Planning Commission - Regular Meeting City and Borough of Juneau

February 26, 2019
Assembly Chambers
7:00 PM

Additional Materials

Regular Planning Commission Meeting

It Does Not Meet Code for New Street Construction.

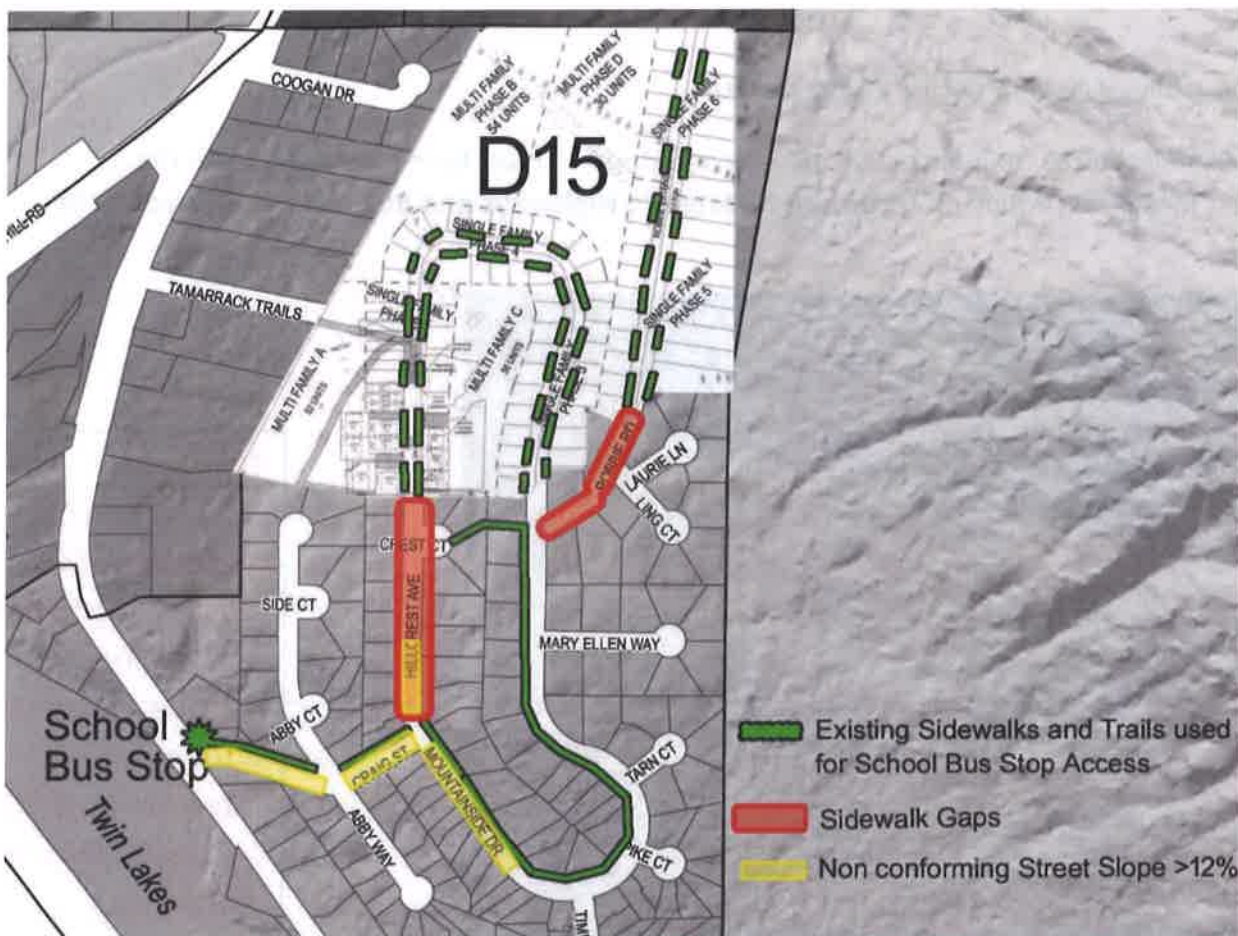
Grade. The grade for the approach leg of a new roadway at an intersection must not exceed two percent for the first 30 feet, measured from the edge of the existing roadway. The grade for the next 70 feet of the new roadway **must not exceed six percent** (See Figure 1).

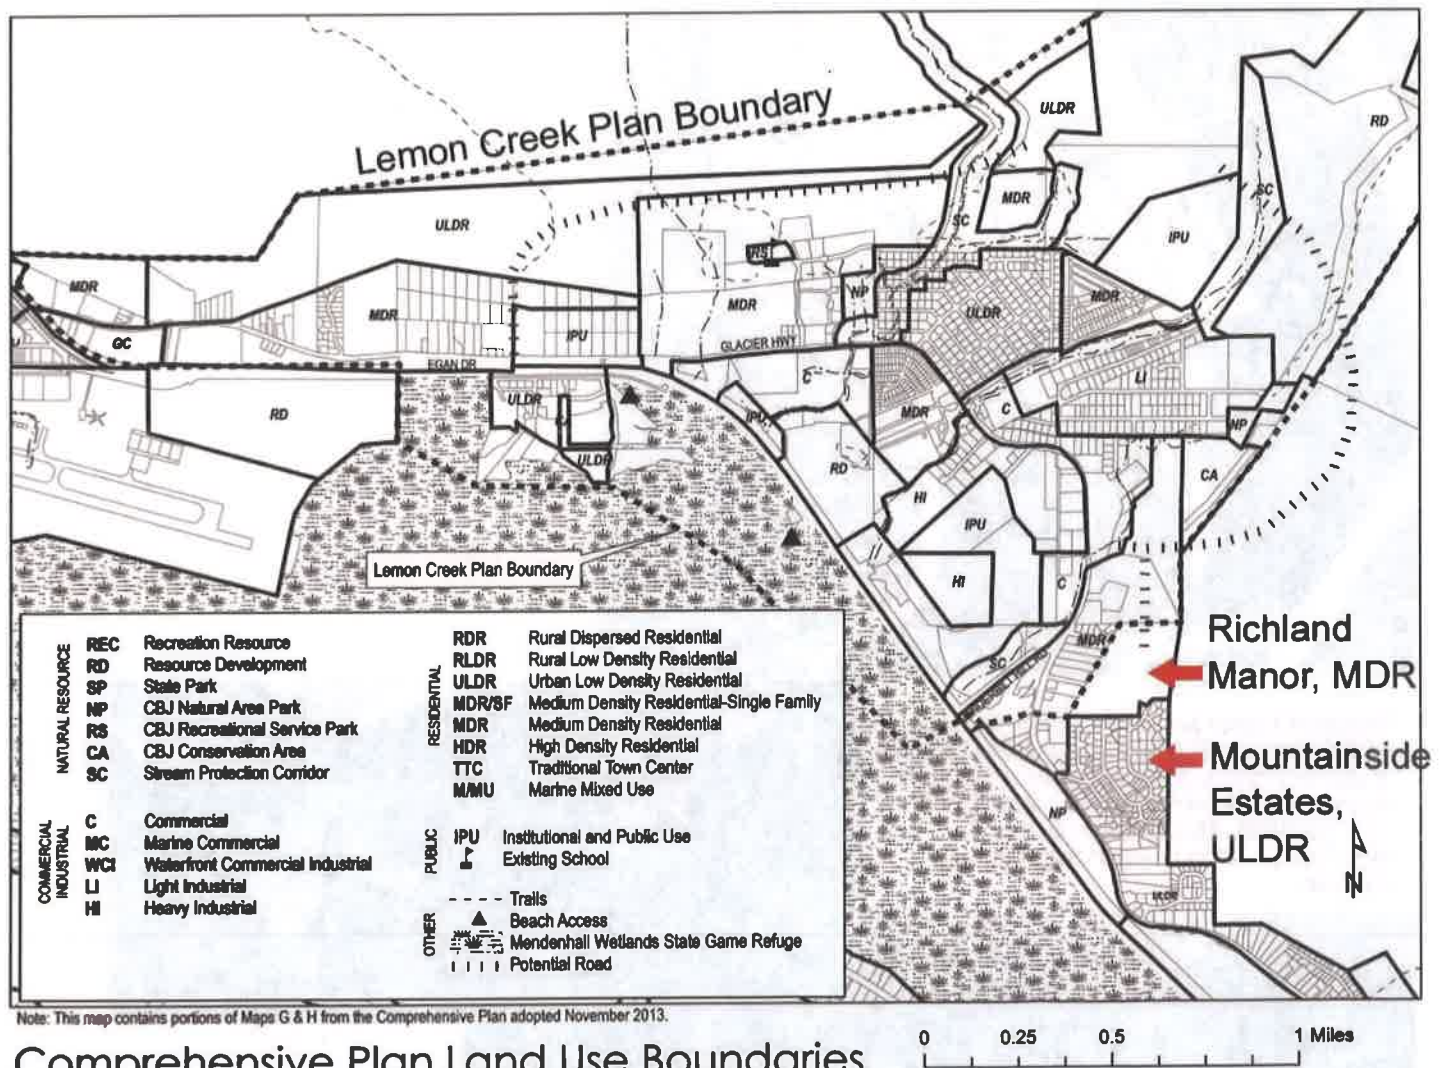
Action item 1: Ensure that land use decisions and transportation projects promote neighborhoods and **create or enhance buffers between different land uses and/or zoning districts.**

Richland Manor does not have any buffers or separation. In Juneau this is usually done by separating road access.

Comprehensive Plan, Adopted 2013

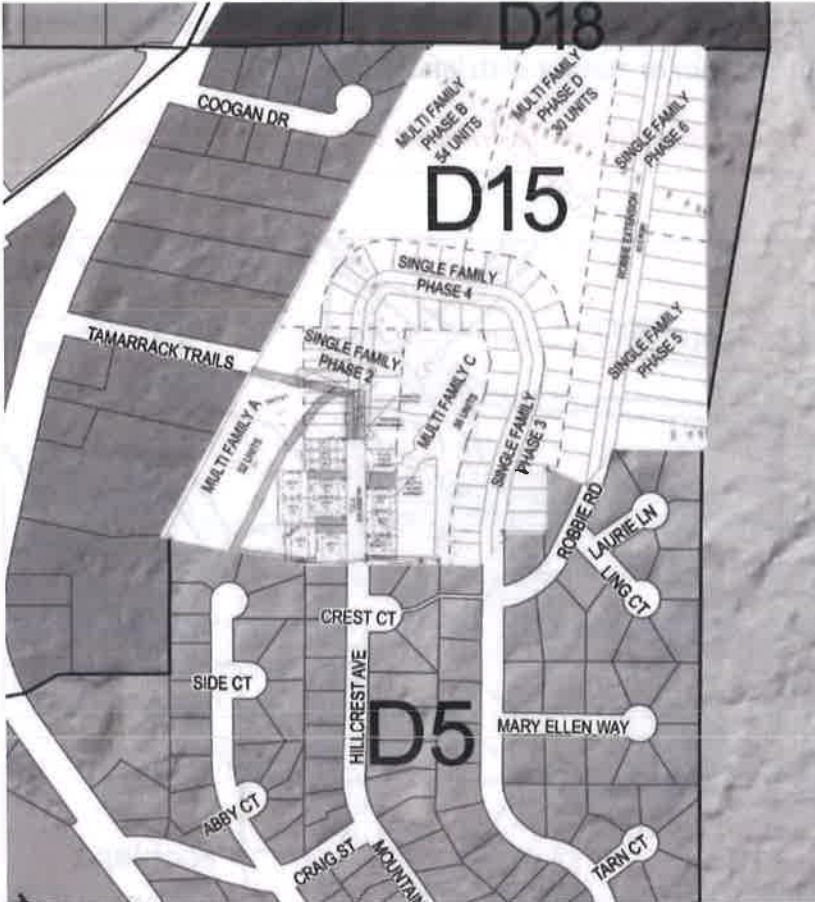
Chapter 10 Land Use, Policy 10.4 - IA1 Seek to reduce or eliminate conflicts between medium or high density residential uses in established low density residential neighborhoods by encouraging the design of higher density housing to be **compatible in scale, massing and orientation with the adjacent, lower-density housing and to hide or screen the parking behind or within the structure(s).**

Richland Manor proposes Bungalow lots with ~30' frontage. There are very few examples in Juneau of this type of lot, manufactured homes are the most common example of ~30' frontage. They also propose 56 multifamily unit housing along Hillcrest Avenue.

Land Use Designation Map, Comprehensive Plan 2013

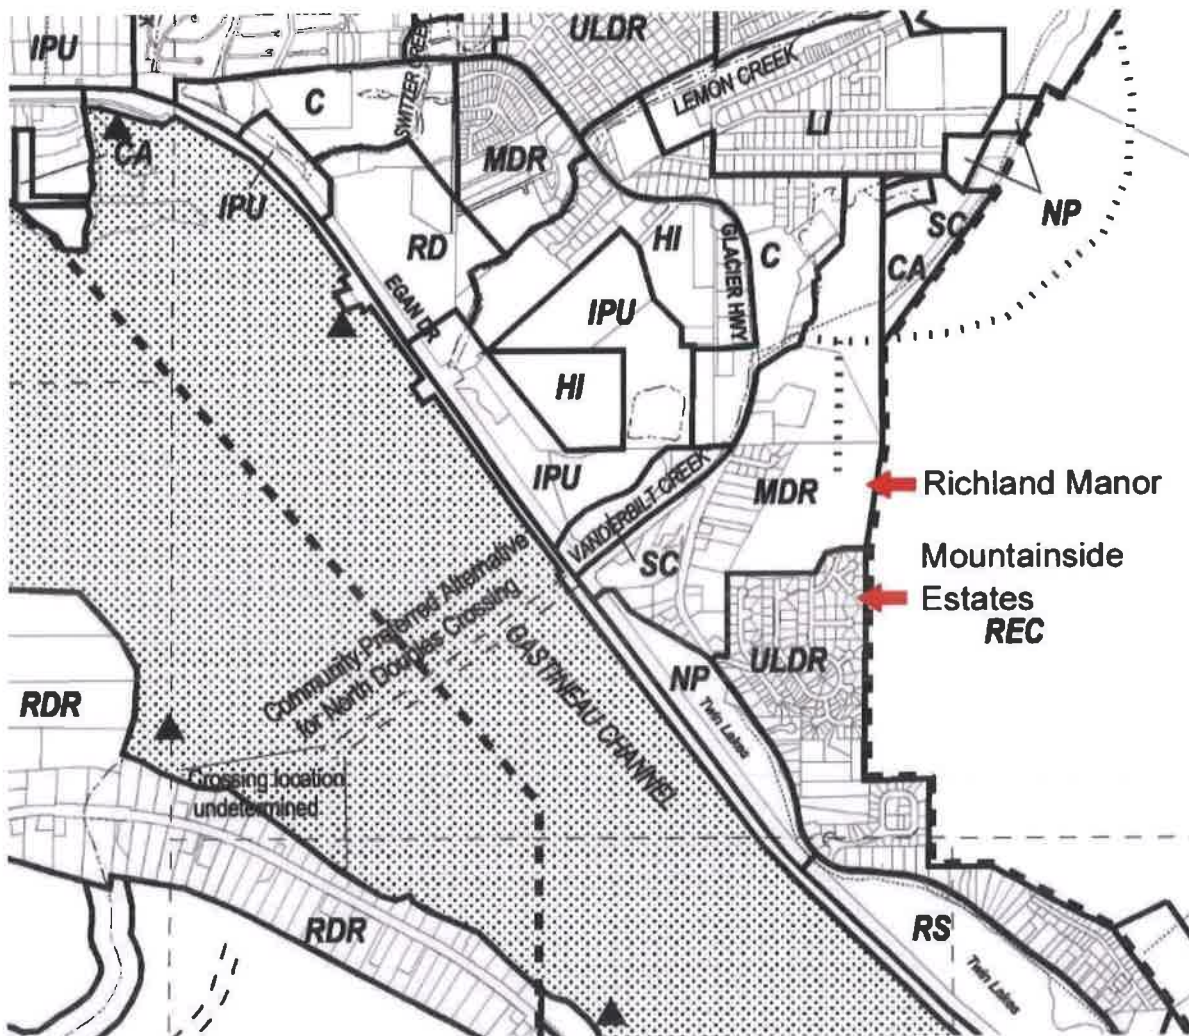
Allowing Richland Manor, MDR, Access Through Mountainside Estates, ULDR, is Precedent Setting.

Land Use Areas front collectors or arterials so they don't have to cross other land use areas. The Richland Manor and MDR area was created with frontage to Glacier Highway. Higher density developments should not go through lower density for egress. That is incongruous planning and design.

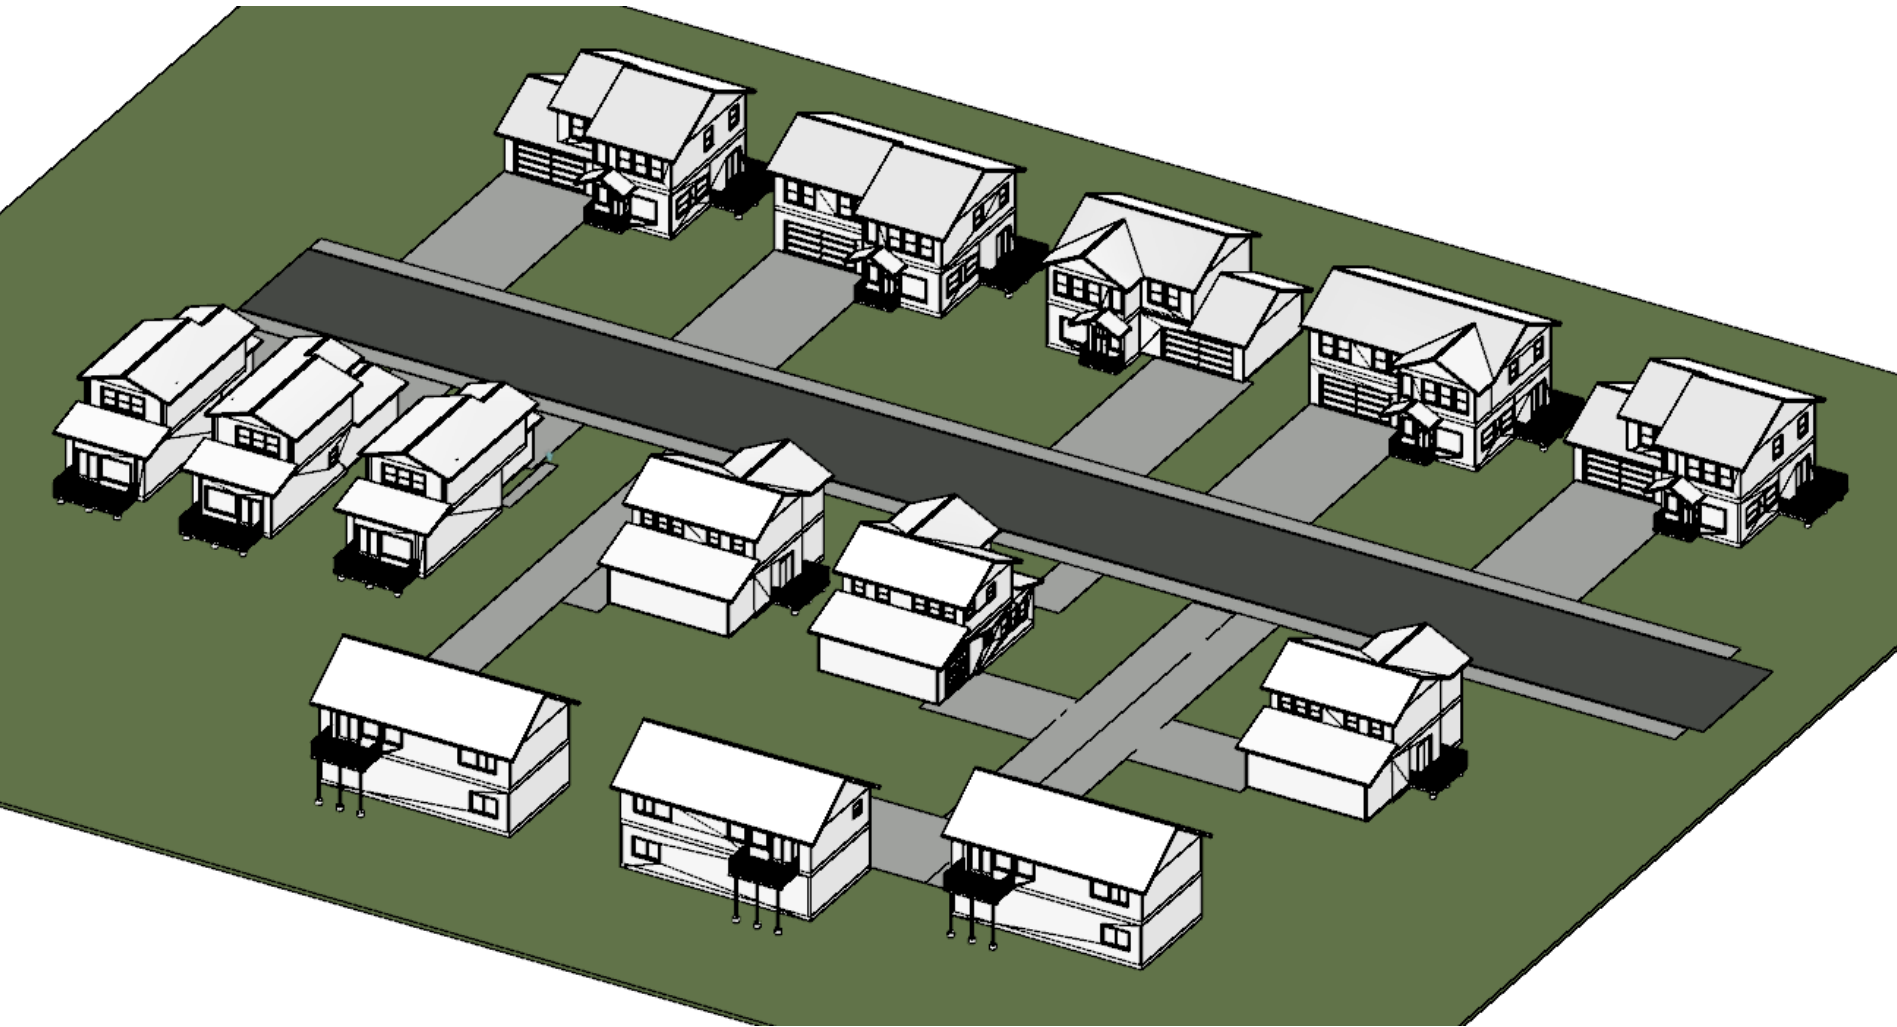
Access has been a main concern with every proposed development of Richland Manor. The platted right of way (ROW) is Hooter Lane and fire code requires a second access if 200 or more units, with sprinklers, are constructed. Our neighborhood opposes being a primary or secondary access. We are willing to compromise and become an emergency only access. This could be accomplished via gate or removable barrier. According to the Fire department, this means a second access would be required after 42 sprinkled units since Mountainside already has 157. The problem with sprinkled units is water pressure. Currently, the upper homes of Mountainside have water pressure issues. This will only get worse with more units and higher floors on multi-unit complexes. Since a second access will be required and the need for an improved water system will be necessary, these are two more reasons why a separated subdivision should be considered.

Access through our neighborhood creates several serious concerns: more crime, incompatible neighborhood harmony, safety, traffic, lower property values, water pressure and construction traffic. Several of my neighbors will testify in more detail regarding these concerns.
